1 **SUBJECT: Internal Expert Analysis Report**

2
3 **REFERENCE: LCA - Executive Summary, p. ii**

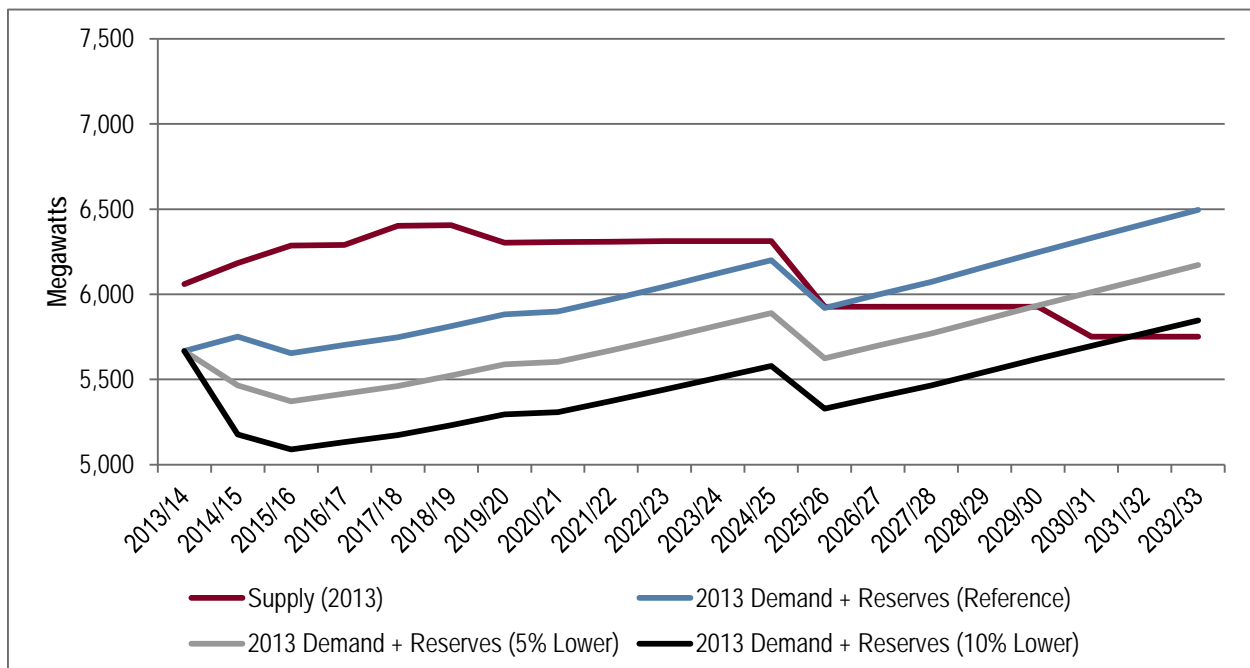
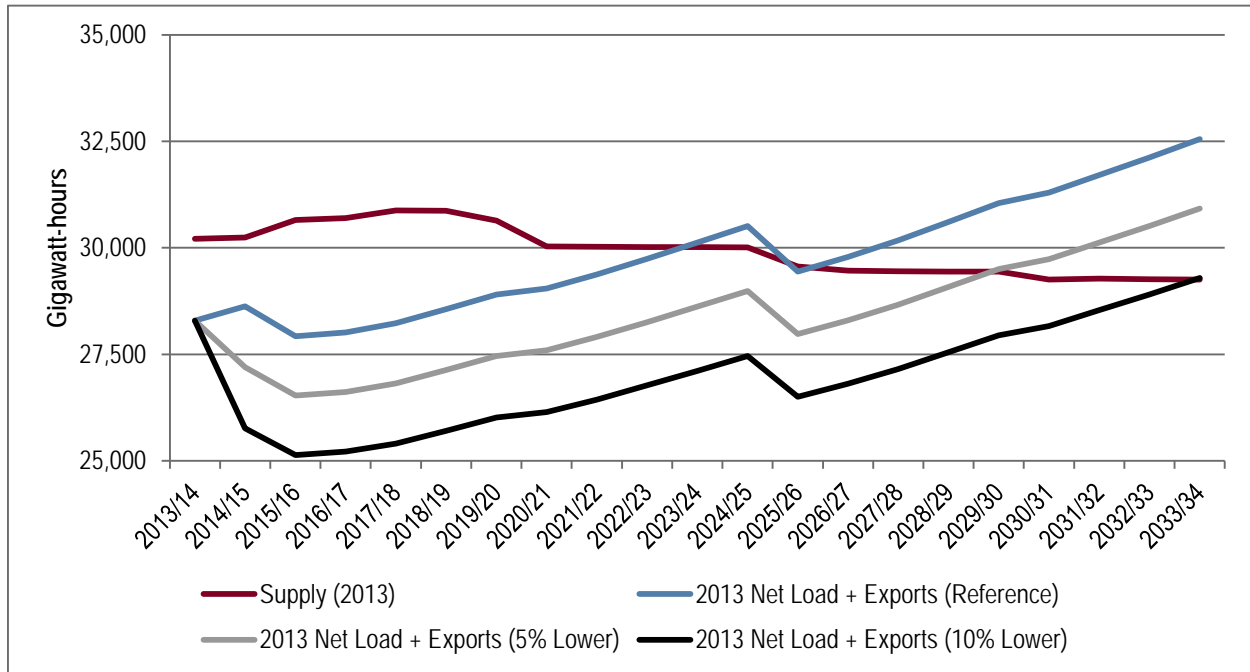
Please provide a sensitivity analysis of both a 5% and 10% lower domestic load going forward
from 2013/14, indicating the potential deferral of new generation.

See below for revised versions of Figures 1-7 (capacity) and 1-15 (energy) with lower load
forecasts.

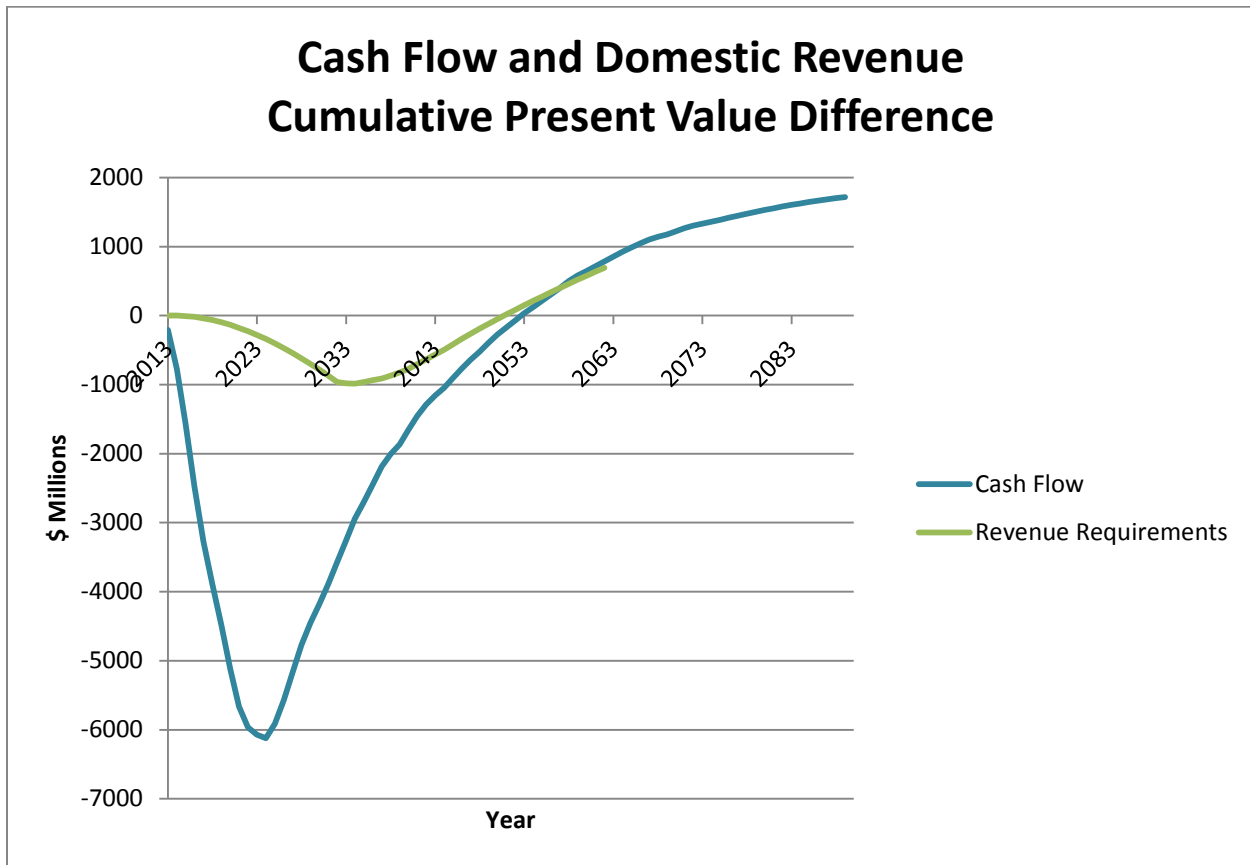
10 Did LCA carry out either a revenue requirement analysis or internal rate of return analysis on
11 the preferred development plan, the all gas scenario and other scenarios. If so please provide in
12 summary format.

19 The chart below shows the cash flow and total domestic revenue comparison for the Preferred
20 Development Plan on a cumulative present value basis relative to the All Gas plan.

REFERENCE: LCA Report Appendix 1 Page I-39

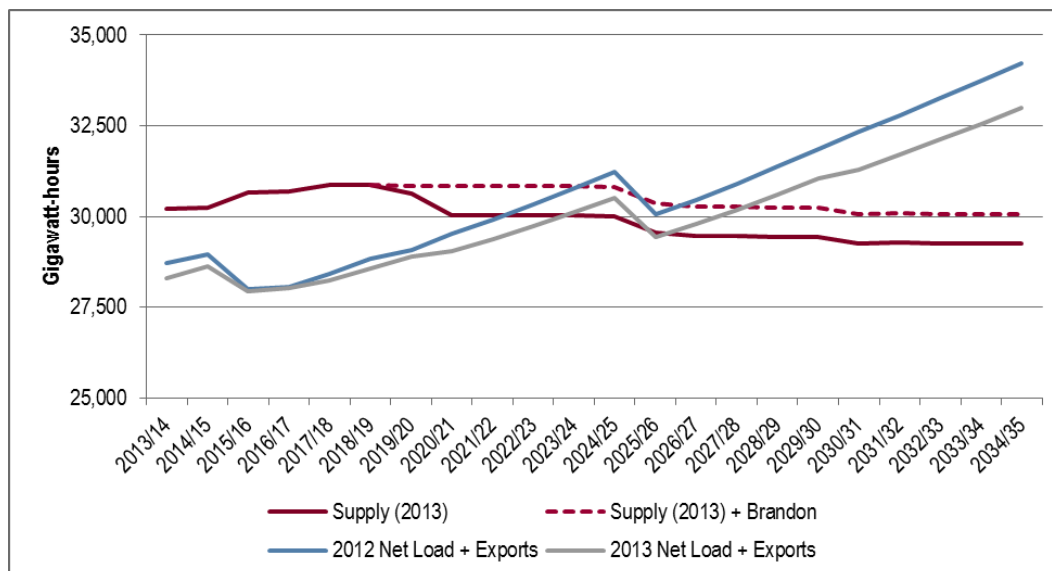
PREAMBLE: Brandon Coal unit # 5 produces up to 810 GWH at 105 MW, which is equivalent to two years of domestic load growth.

Due to the expiration of export contracts after 2024/2025, there is a steep drop in the level of net load plus exports. Using the 2013 supply and demand data, this expiration of the export contracts occurs before demand exceeds supply. Figure 1-19 is reproduced below. If the grey “2013 Net Load + Exports” line continued to increase with load growth, the continued service of Brandon Unit 5 would only delay resource need by two years. However, the dependable energy provided by Brandon Unit 5 delays resource need until after load growth replaces the demand reduction caused by the expiring contracts.

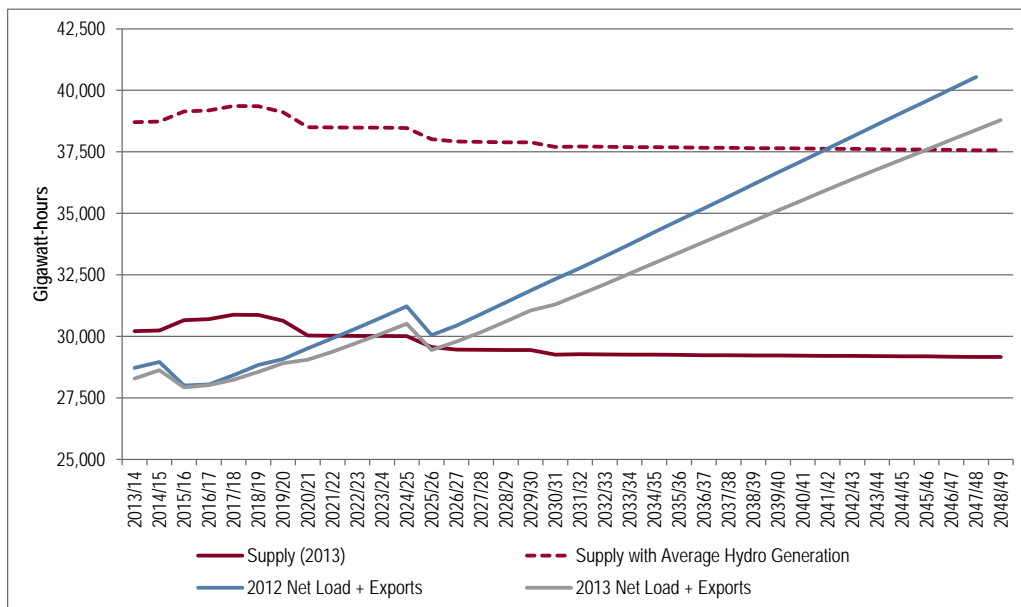
15 Provide a summary matrix which illustrates LCA's various potential Keeyask and or Conawapa
16 deferrals and indicated whether any of the measures are additive, correlated, or not.

24 The following matrix summarizes the impacts each item has on the year of capacity or
25 dependable energy need under 2013 Update assumptions. The impact of each item is shown
26 separately, i.e. none are added together. A case with multiple factors was modeled as the LCA
27 No New Generation case, which is described in Technical Appendix 3B. The references refer to

- 3
- 4 **Figure 1 GWh comparison between PDP and K19/C25/250MW**

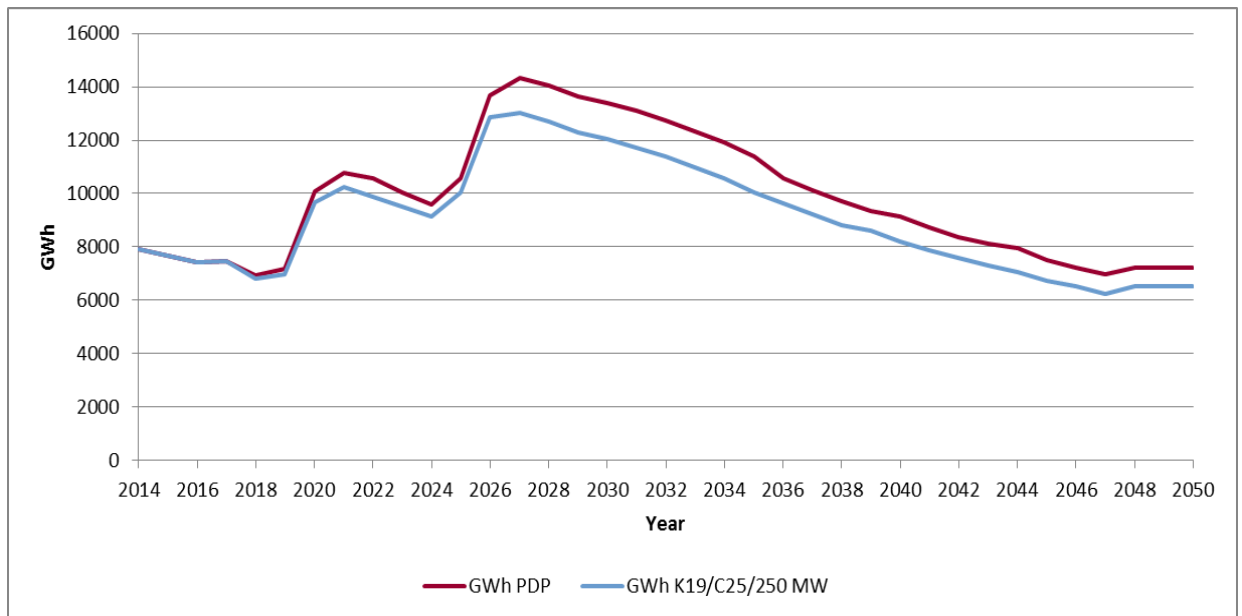
14 Please provide a chart similar to Figure 8-34 showing the GWh of total exports achieved by the
15 PDP relative to K19/C25/250MW.

18 Figure 1 shows the total export sales (GWH) achieved by the PDP relative to K19/C25/250 MW,
19 which is a summation of the following export products included in the cases:

2 Figure PUB/LCA-092-1

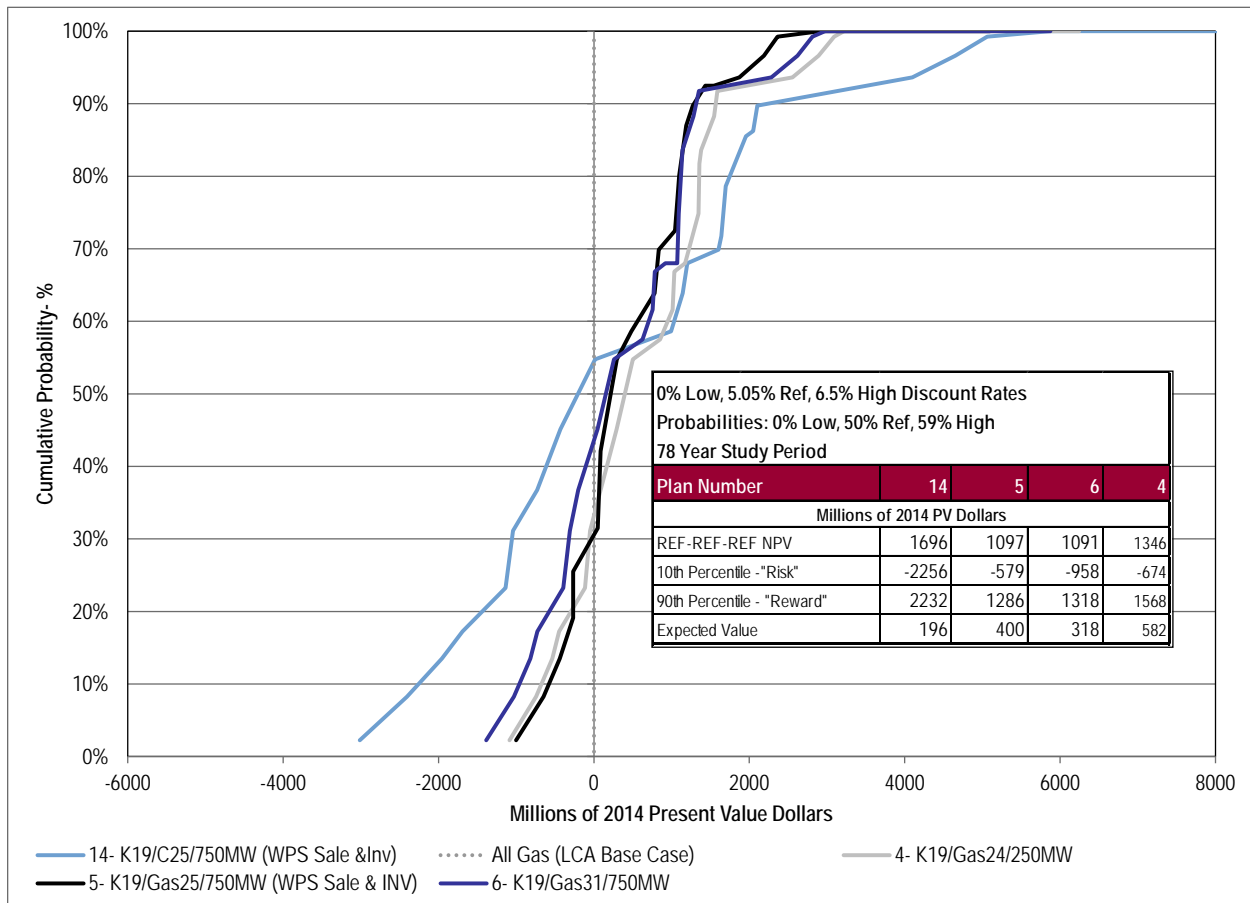
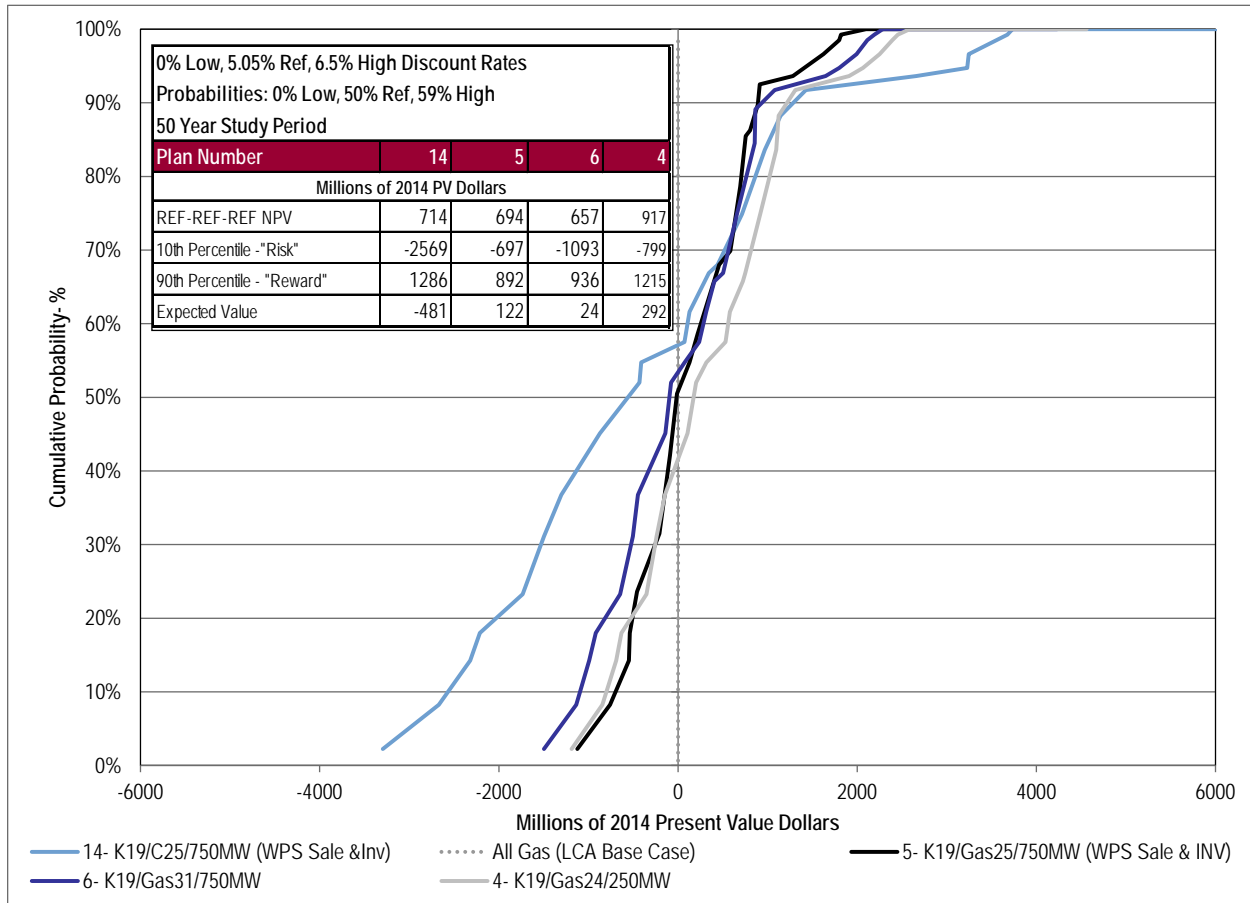
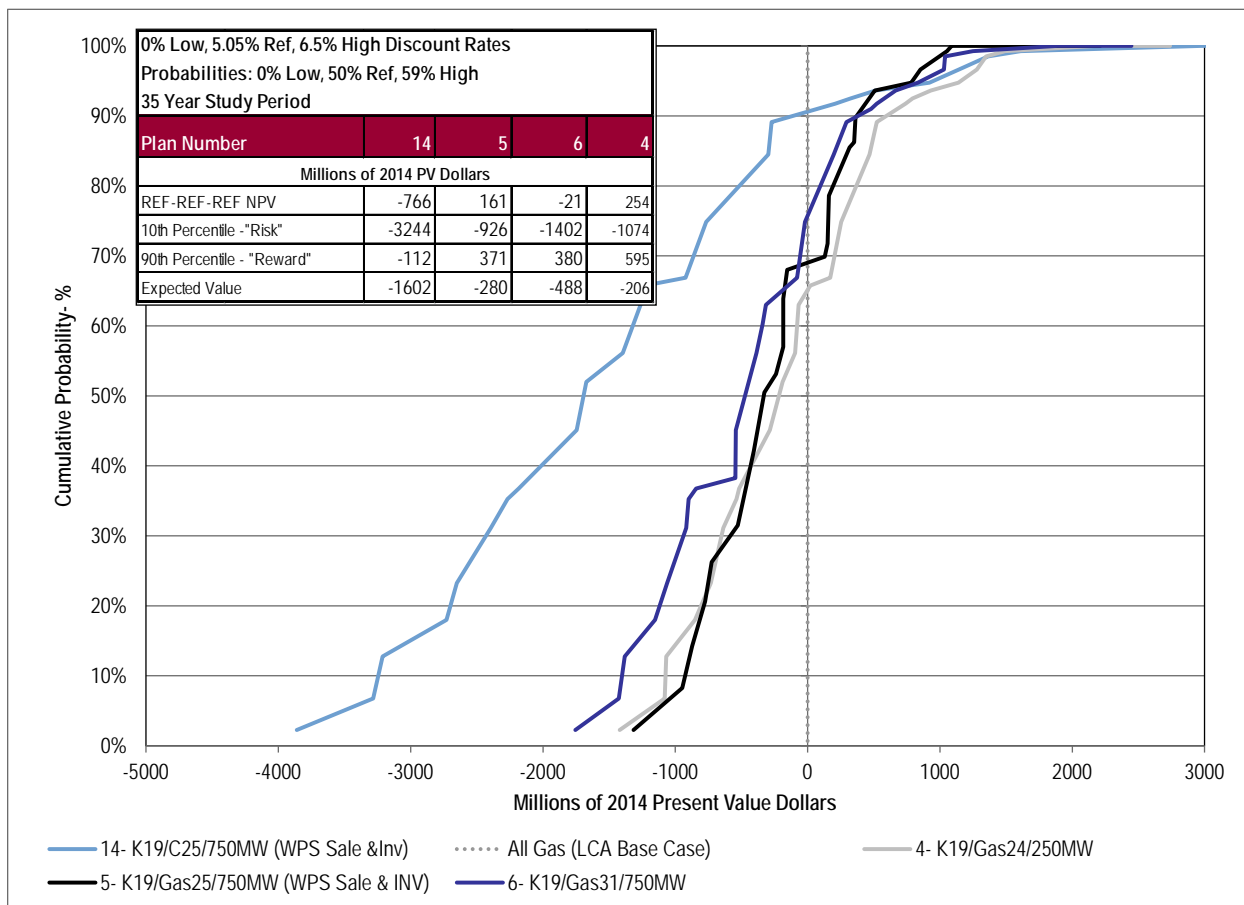
15 Please provide modified Figures 9-42, 9-43 and 9-44, reflecting the elimination of the low
16 discount rate probability based on MPA's low discount rate view and provide commentary on
17 the comparative results.
